North Dakota Department of Transportation

ADDENDUM 1 – JOB 2

TO: All prospective bidders on projects SOIA-7-085(096)192, Job No. 2 scheduled for the May 22, 2014 bid opening.

SRF No. 7594

Revised 05/12/14	STATE	PROJECT NO.	SECTION NO.	SHEET NO.
	ND	SOIA-7-085(096)192	140	1

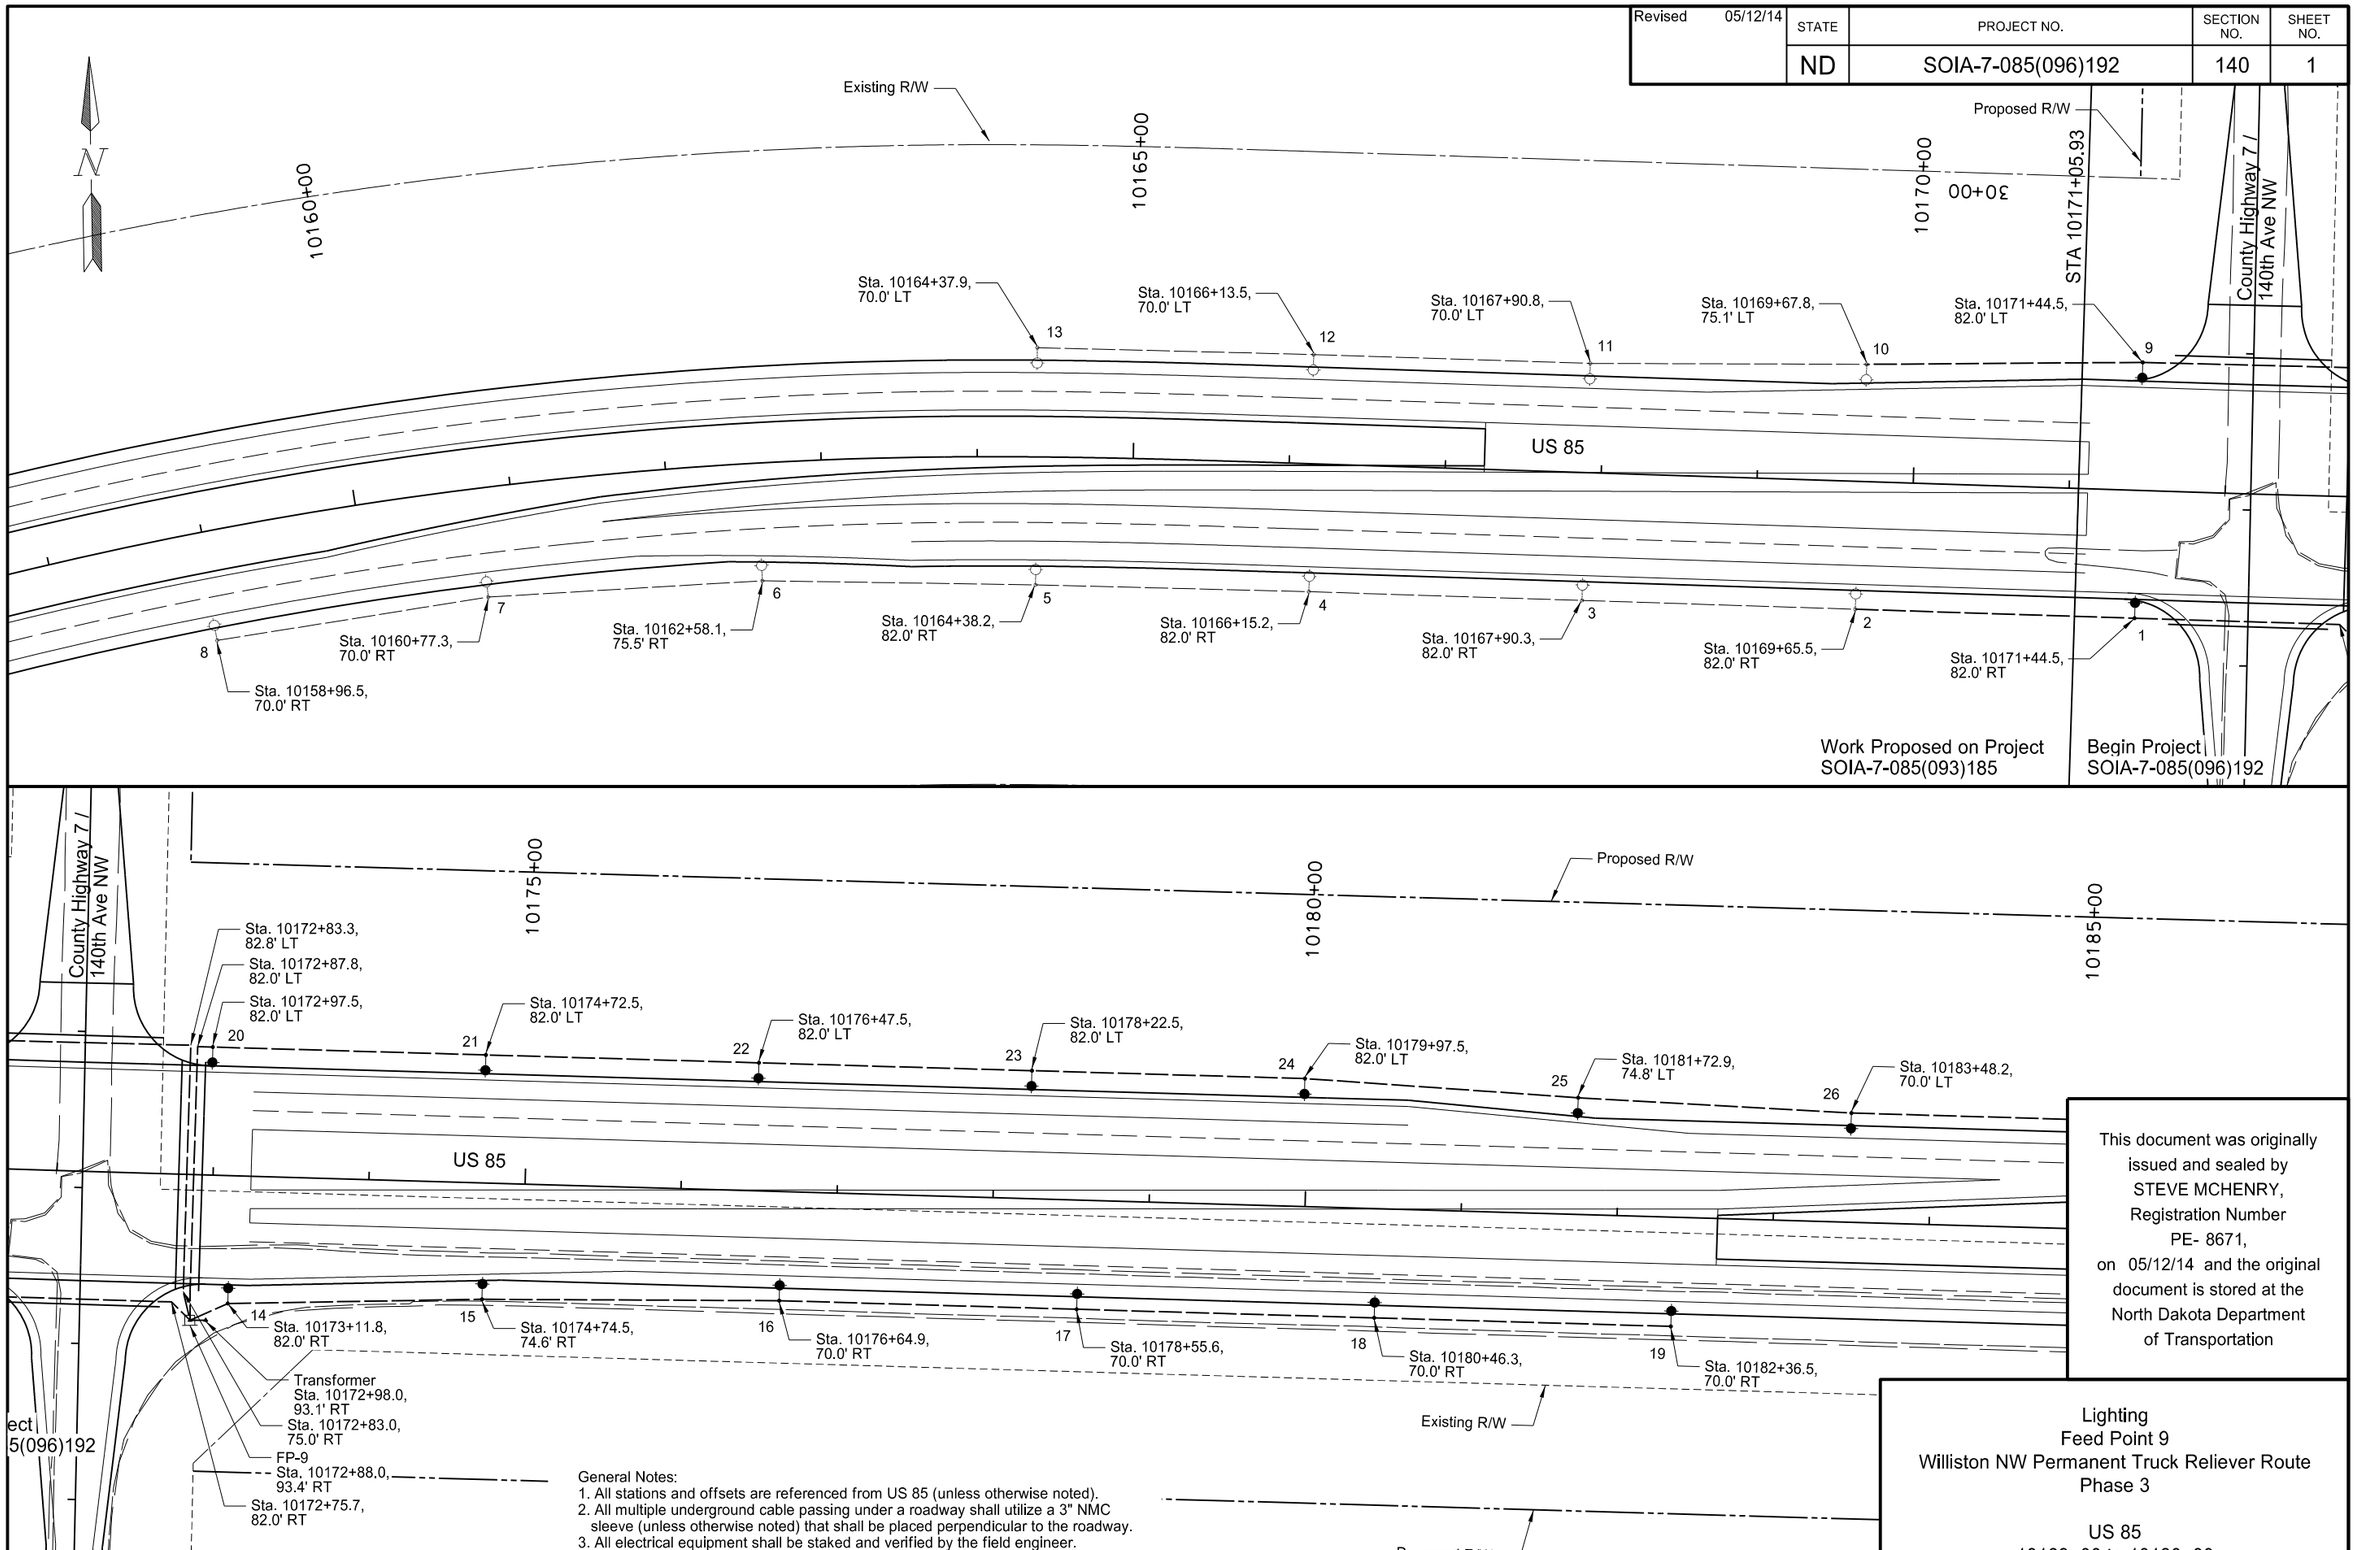
Sheet 140-1:
Relocated lighting units 1 and 9 due to drainage pipe conflict.

Revised 05/12/14	STATE	PROJECT NO.	SECTION NO.	SHEET NO.
	ND	SOIA-7-085(096)192	140	9

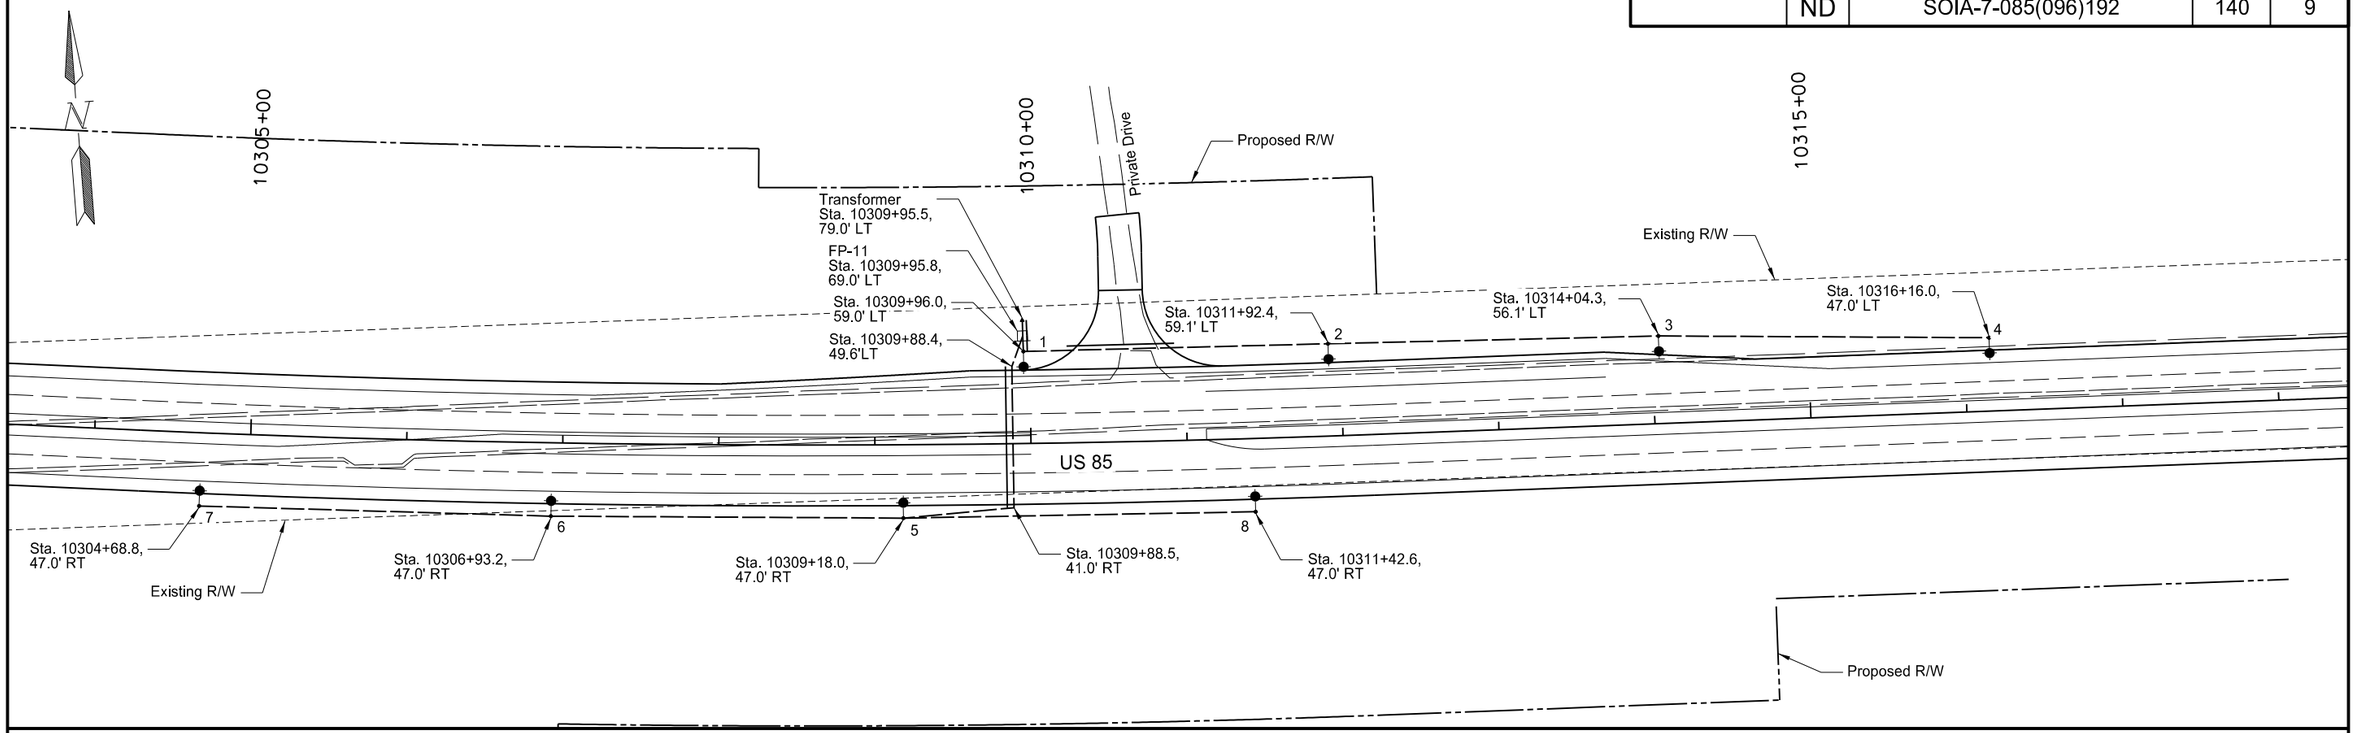
Sheet 140-9:
Relocated lighting units 2, 3, and 4 due to drainage pipe conflict.

Revised 05/12/14	STATE	PROJECT NO.	SECTION NO.	SHEET NO.
	ND	SOIA-7-085(096)192	140	18

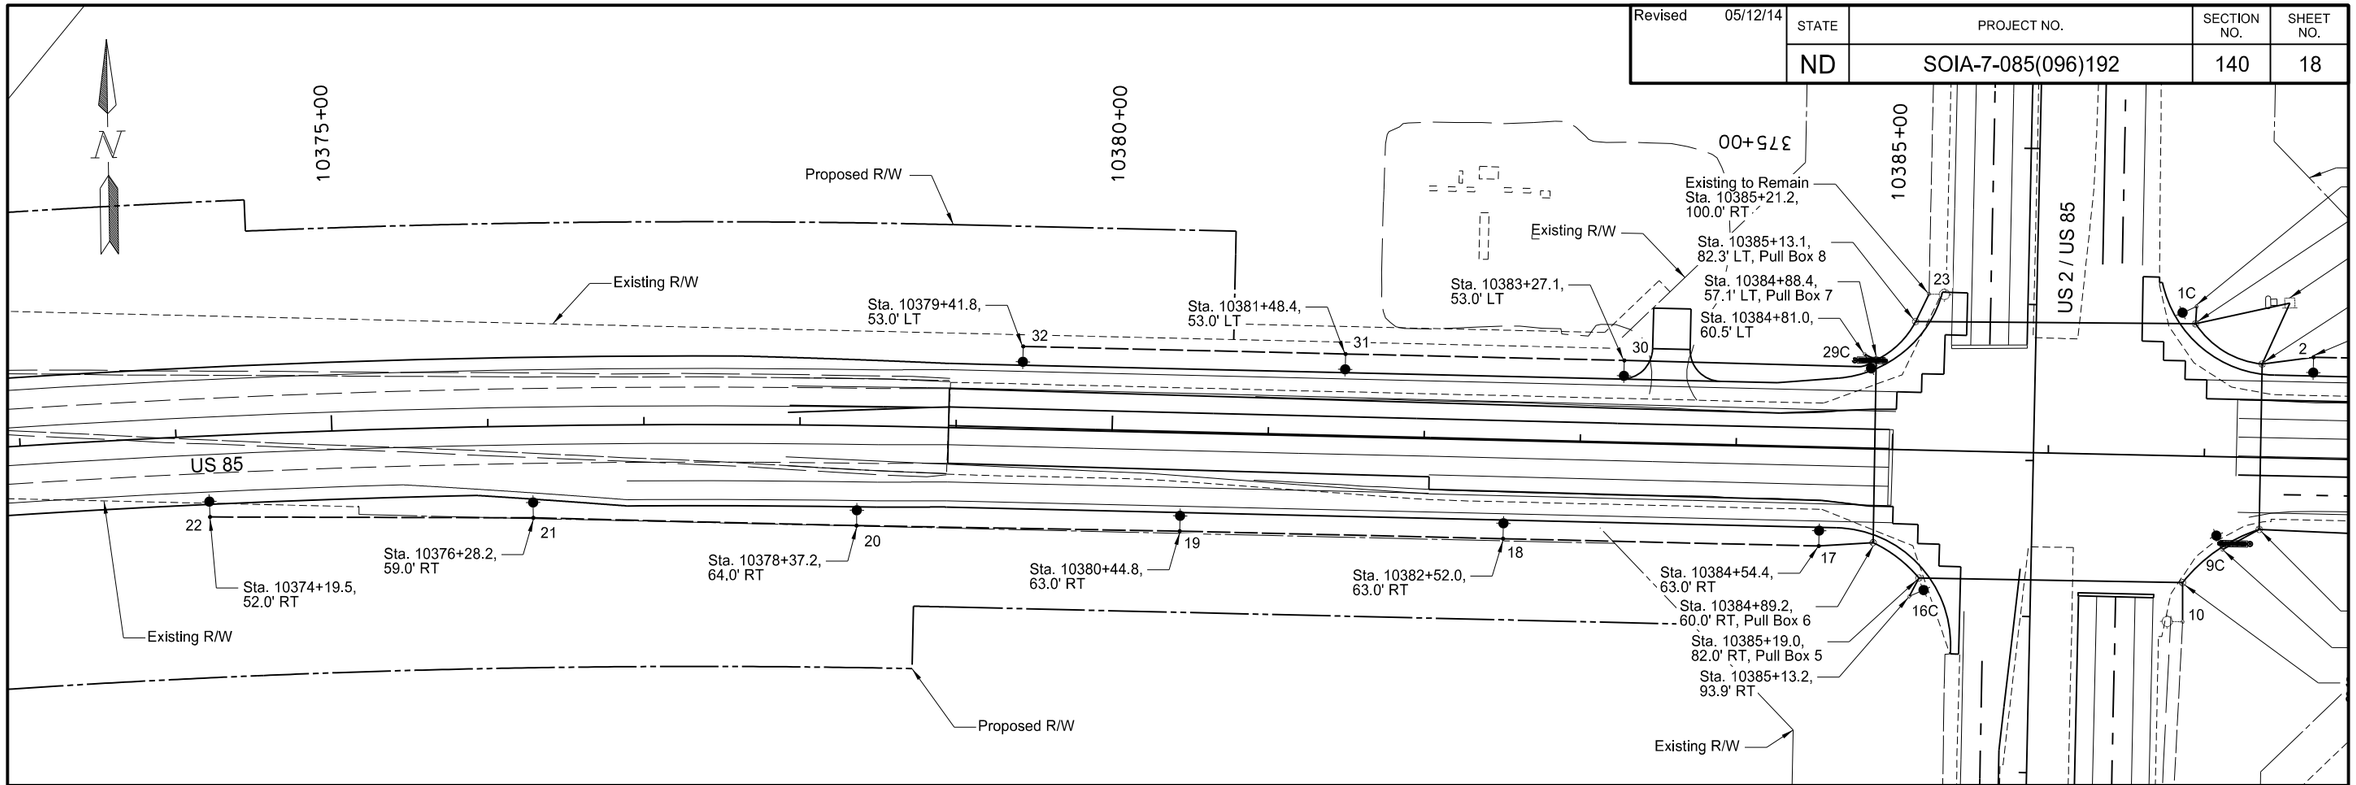
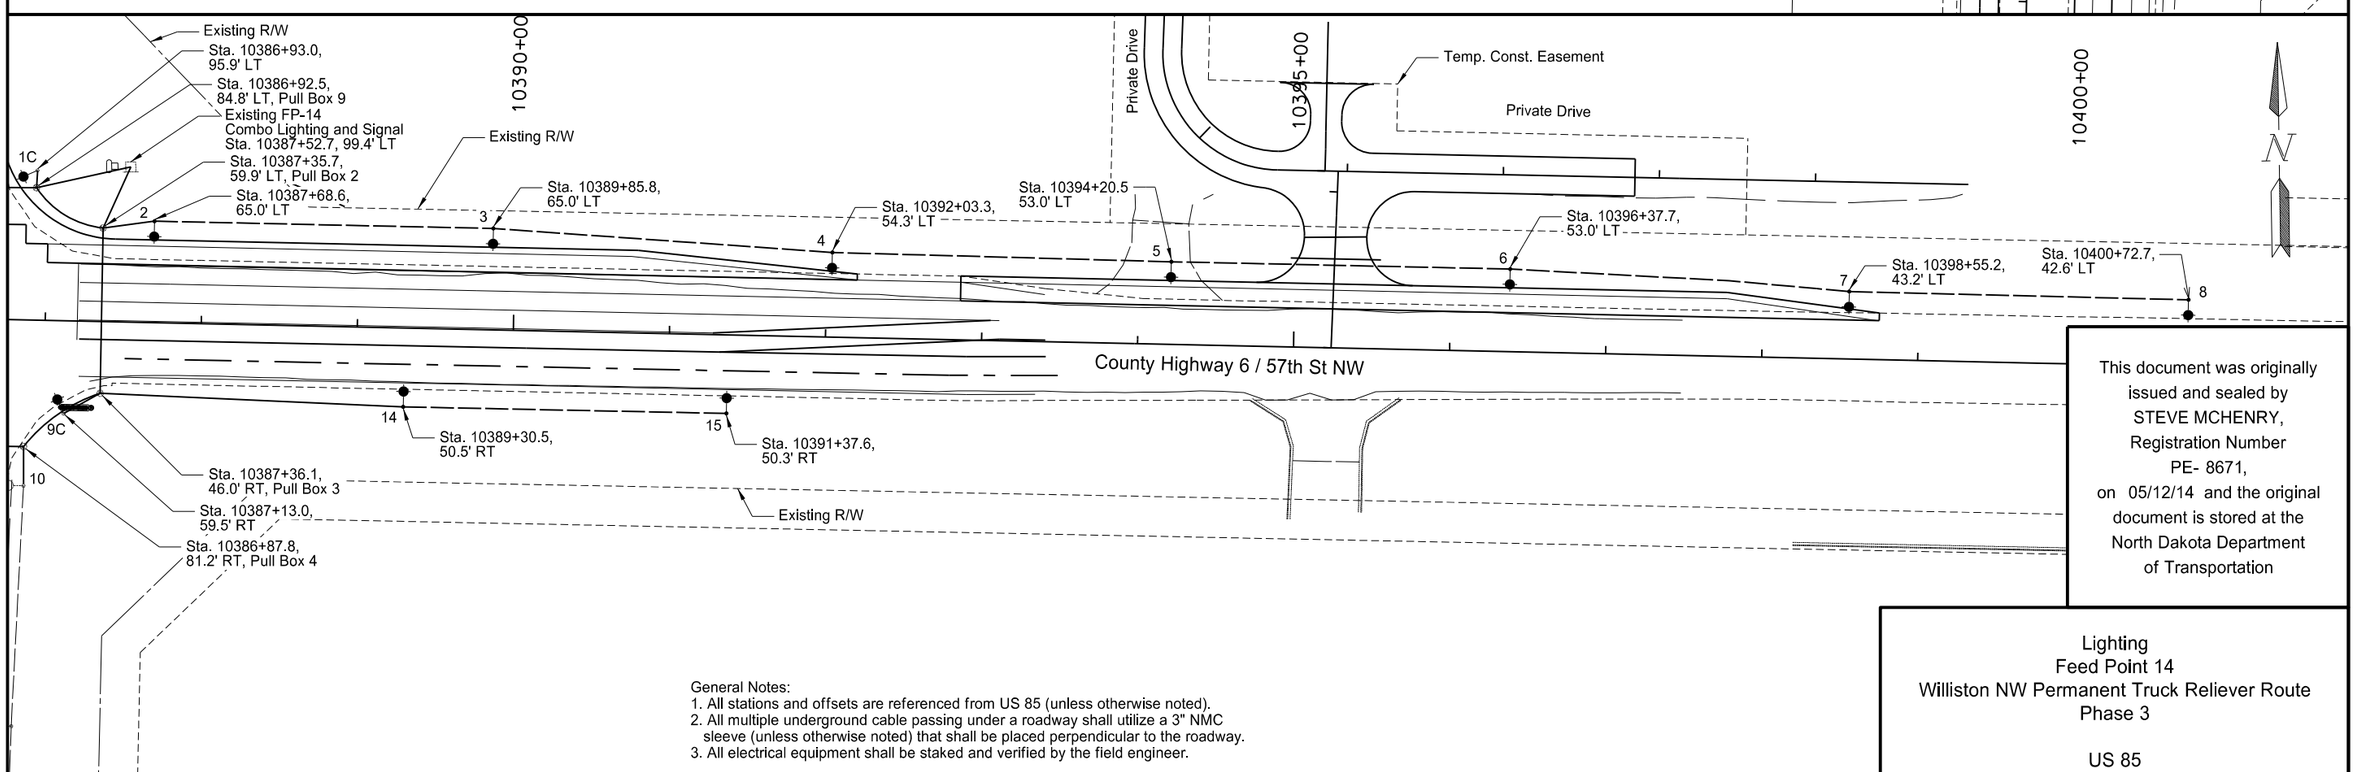
Sheet 140-10:
Updated stations and quantities based on light units 2, 3, and 4 relocating.
Sheet 140-18:
Relocated lighting unit 7 due to drainage pipe conflict.

Revised 05/12/14	STATE	PROJECT NO.	SECTION NO.	SHEET NO.
	ND	SOIA-7-085(096)192	140	19

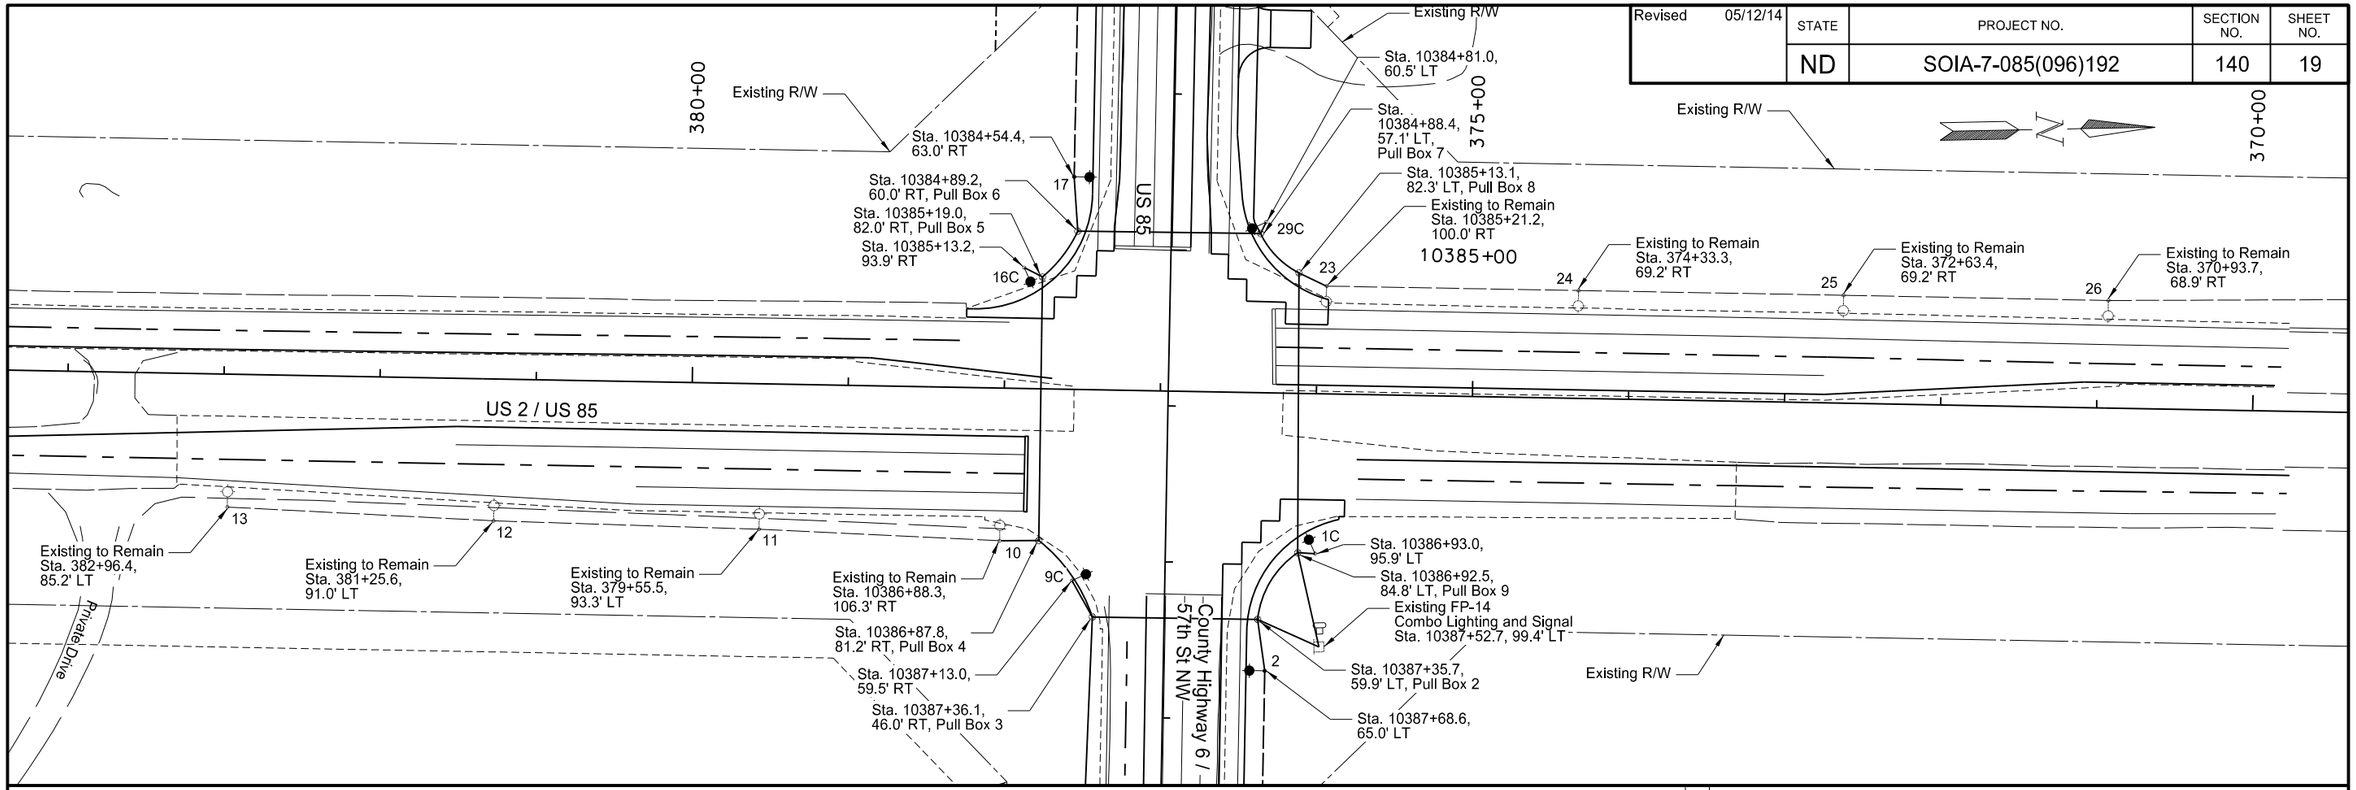
Sheet 140-19:
Relocated lighting unit 7 due to drainage pipe conflict.
